CITY OF LA VISTA
MAYOR AND CITY COUNCIL REPORT
JULY 5, 2023 AGENDA

Subject:	Type:	Submitted By:
CONDITIONAL USE PERMIT – HUBBELL DEVELOPMENT SERVICES – LOT 2 MAYFAIR 2 ND ADDITION REPLAT THREE AND LOTS 1, 2, AND 3 MAYFAIR 2 ND ADDITION REPLAT SEVEN	◆ RESOLUTION ORDINANCE RECEIVE/FILE	CHRISTOPHER SOLBERG DEPUTY COMMUNITY DEVELOPMENT DIRECTOR

**CITY OF LA VISTA
PLANNING DIVISION
RECOMMENDATION REPORT**

CASE NUMBERS: PPUD23-0003; PCUP23-0004; FOR HEARING ON: JULY 5, 2023
PRP23-0002 REPORT PREPARED ON: JUNE 16, 2023

Exhibit A - Sidewalk Additions

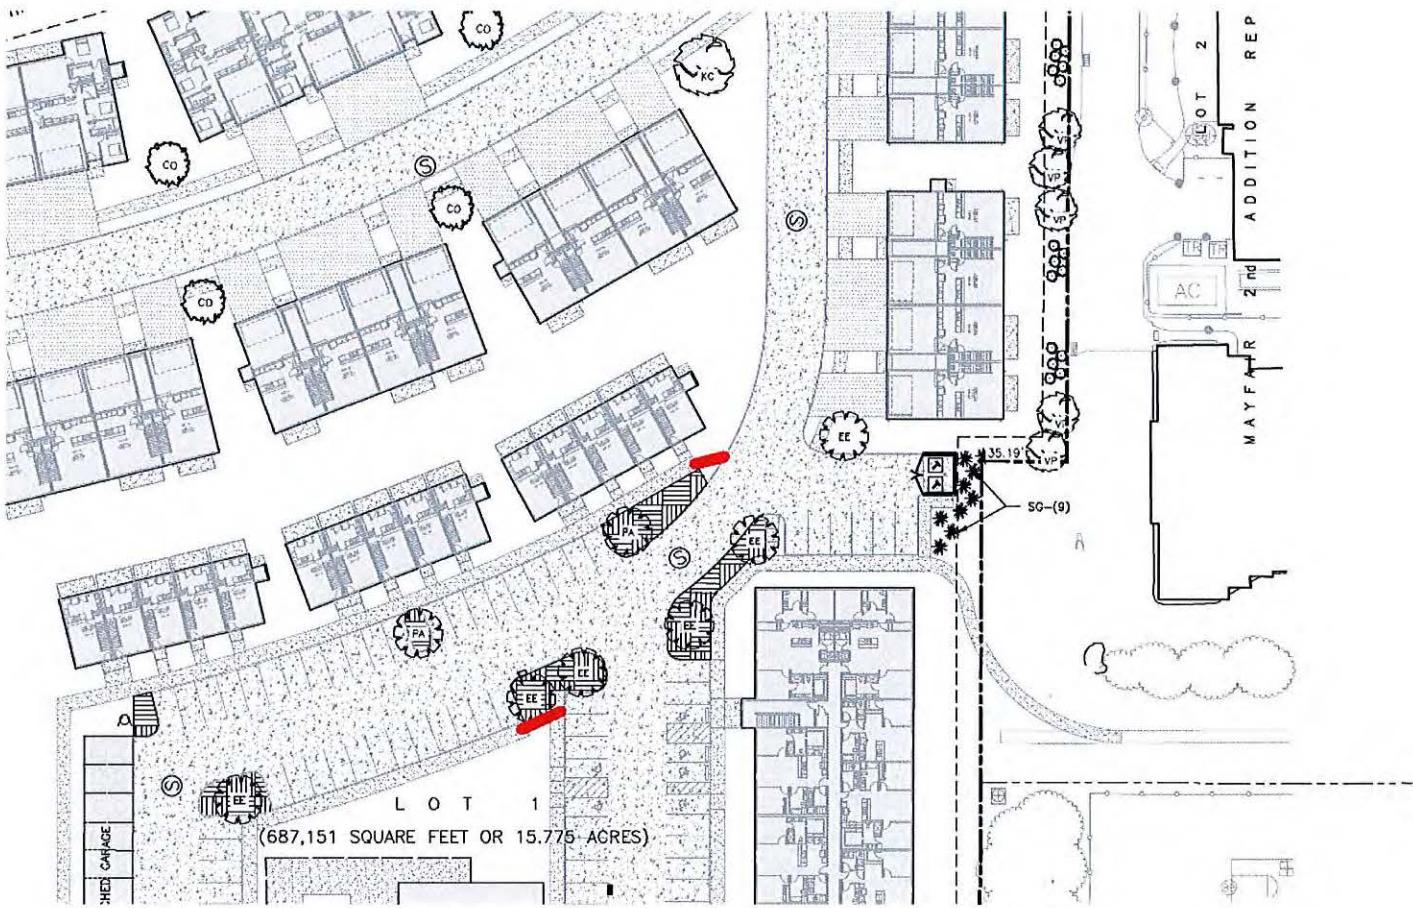
6. Zoning Ordinance Section 5.15.04.07 and 5.15.04.16 – To complete the sidewalk network in the development to provide adequate pedestrian connectivity, please update the plan to include the two sidewalk connections noted in red on the plan in Exhibit A, attached to this letter.

6. Zoning Ordinance Section 5.15.04.07 and 5.1 5.04.1 6 - To complete the sidewalk network in the development to provide adequate pedestrian connectivity, please update the plan to include the two sidewalk connections noted in red on the plan in Exhibit A, attached to this letter.

Sidewalks have been added per Exhibit A.
